Discontinuation Notice of CPM2C series.

Product Discontinuation

[Dimensions]

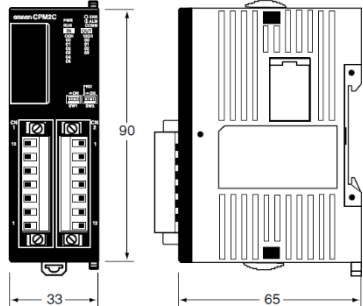
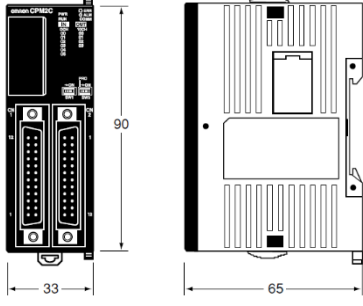
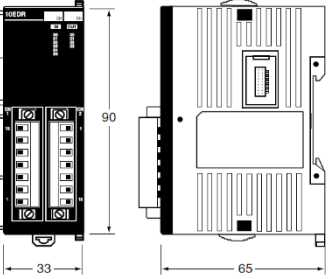
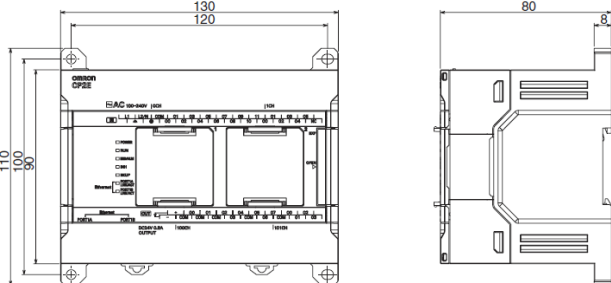
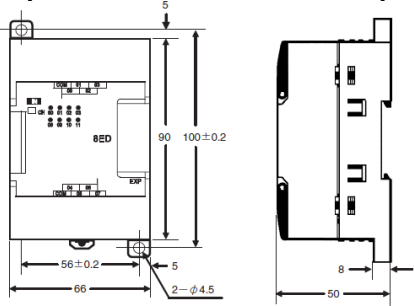
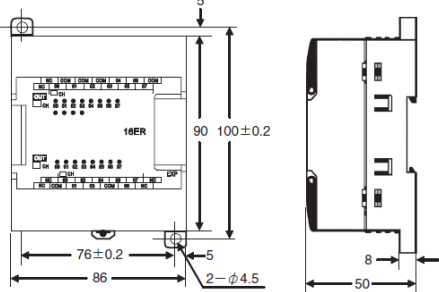
Product discontinuation Model CPM2C series	Recommendable replacement Model CP2E series
<p>CPU Units with 10,20 I/O points - I/O terminal block</p>  <p>CPU Units with 10,20,32 I/O points - connector</p>  <p>Expansion I/O Units with 10,20 I/O points - I/O terminal</p>  <p>Expansion I/O Units with 10,24,32 I/O points - connector</p>  <p style="text-align: right;">Unit : mm</p>	<p>All dimensions (H x D x W) are changed from ZEN.</p> <p>CPU Units with 14/20 I/O points</p>  <p>CPU Units with 30 I/O points</p>  <p>Expansion I/O Units with 8 I/O points</p>  <p>Expansion I/O Units with 16 I/O points</p>  <p style="text-align: right;">Unit : mm</p>

[Dimensions]

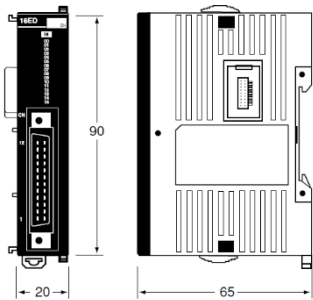
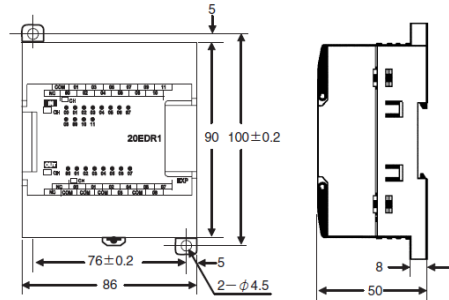
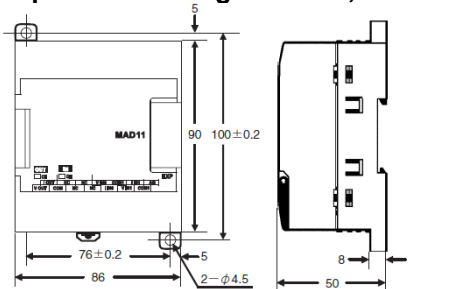
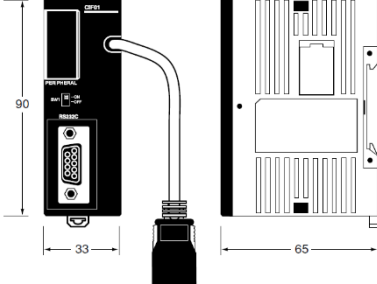
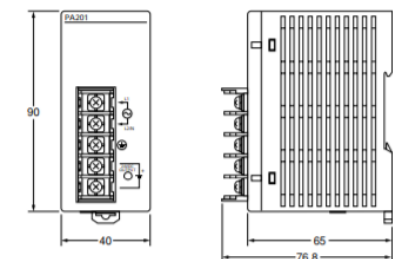
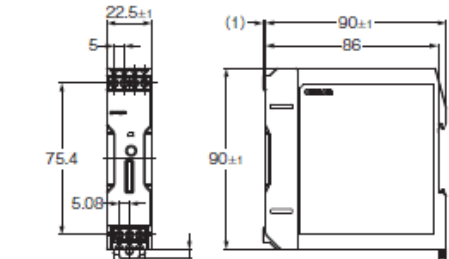
Product discontinuation Model CPM2C series	Recommendable replacement Model CP2E series
Expansion I/O Units with 8,16 I/O points -connector 	Expansion I/O Units with 20 I/O points 
Expansion Analog I/O Units ,TS units 	Expansion Analog I/O Units, TS units 
Adapter units 	
Power Supply units 	Switch mode power supply Model S8VK-G01524 
<p>Unit : mm</p>	<p>Unit : mm</p>
